DRAINAGE PLAN
STA. 145+00 TO 150+00

FARRINGTON HIGHWAY INTERSECTION IMPROVEMENTS
AT NANAKULI AVENUE AND HALEAKALA AVENUE
Federal-Aid Project No. STP-093-1(22)

CONTRACT CHANGE ORDER NO. 27
Attachment 1

DRAINAGE PROFILES - 5

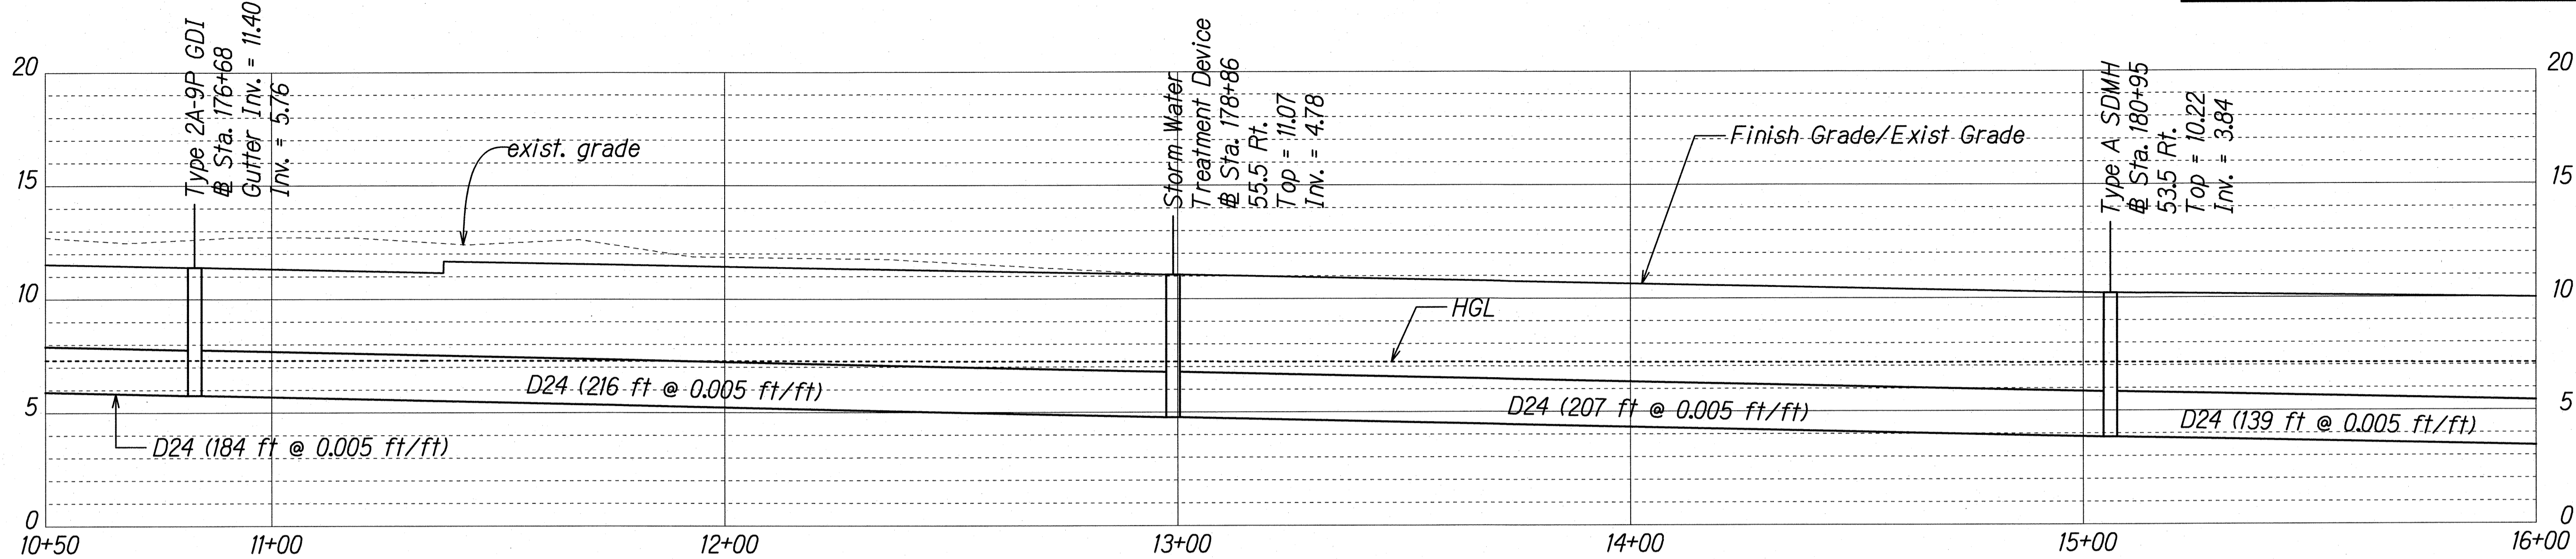
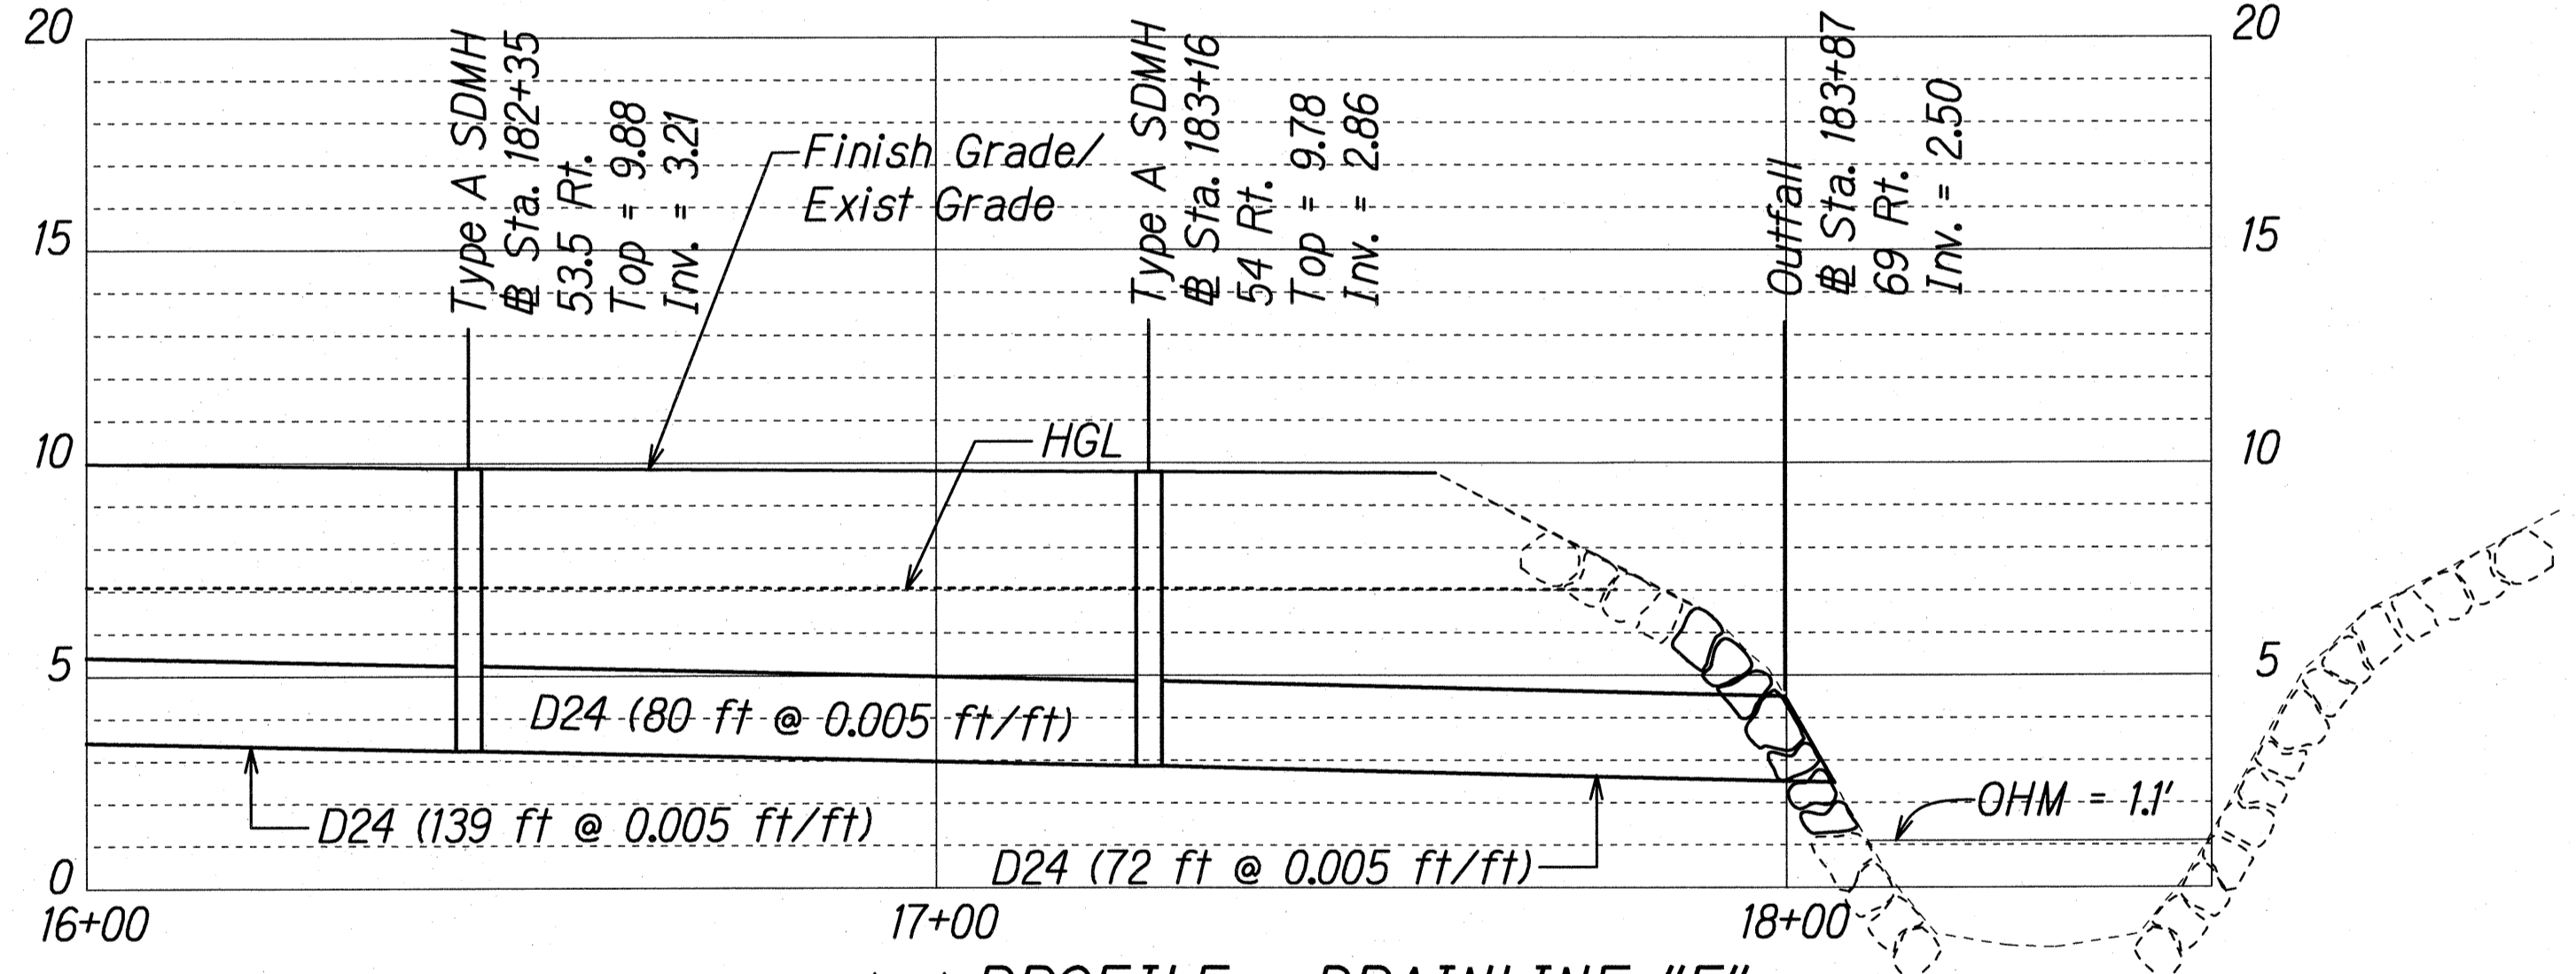
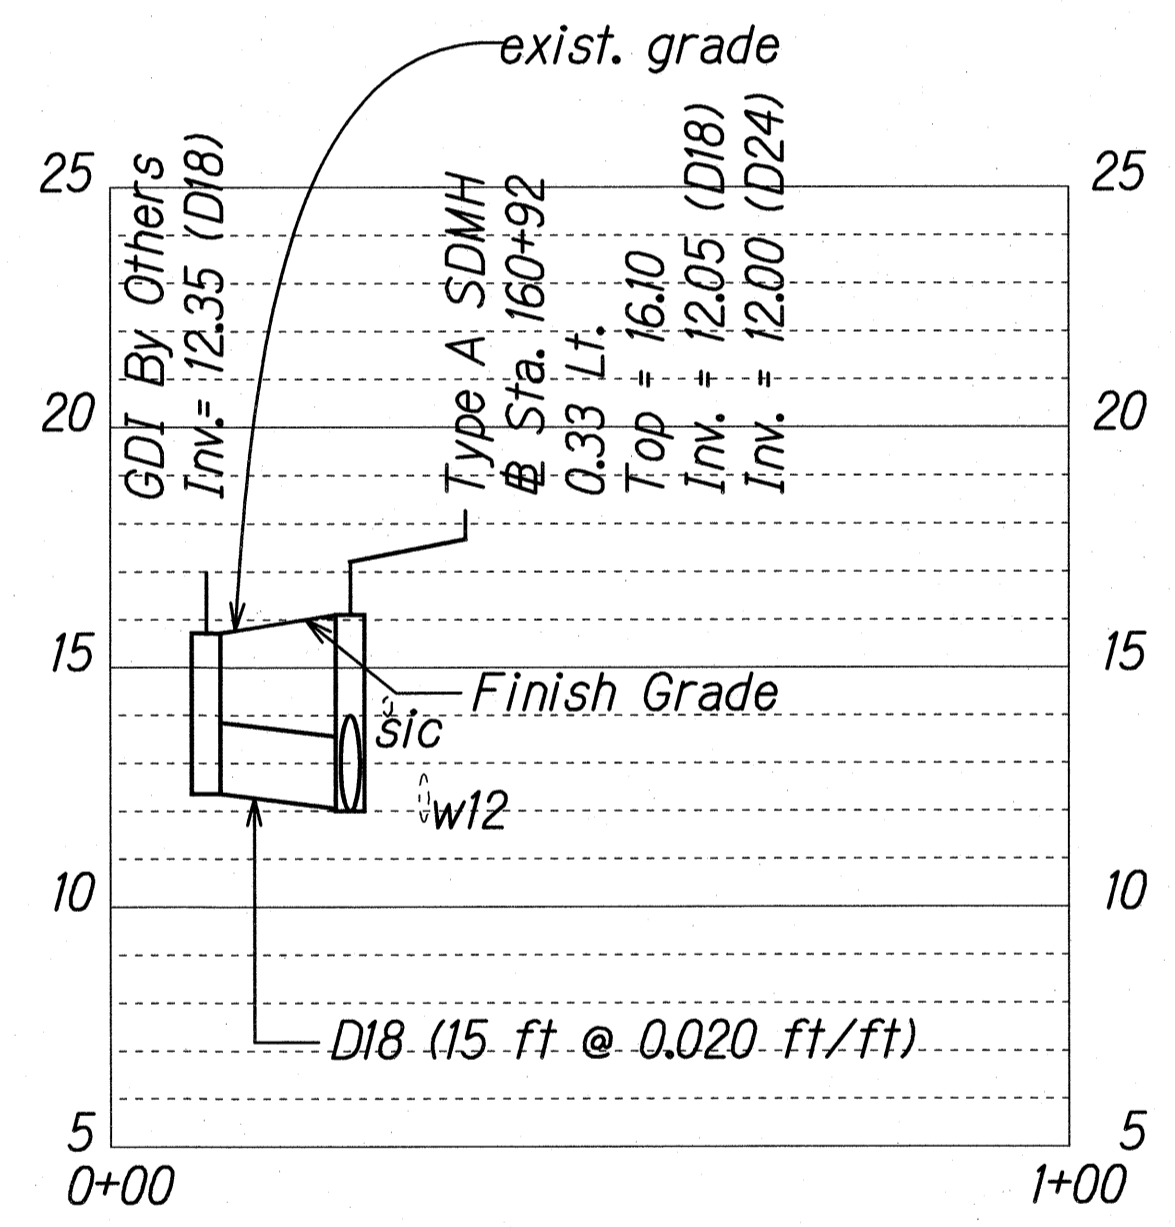
11/17/17	\triangle Revised Drainage Profile "E"
4/22/15	\triangle Revised Drainage Profile "E"
DATE	REVISION

$\triangle \triangle$ PROFILE - DRAINLINE "E"
Scale: Horiz. 1"=20'
Vert. 1"=4'
Note:
All construction work shall occur
above the Ordinary High Water (OHW)
Mark elevation = 1.1'
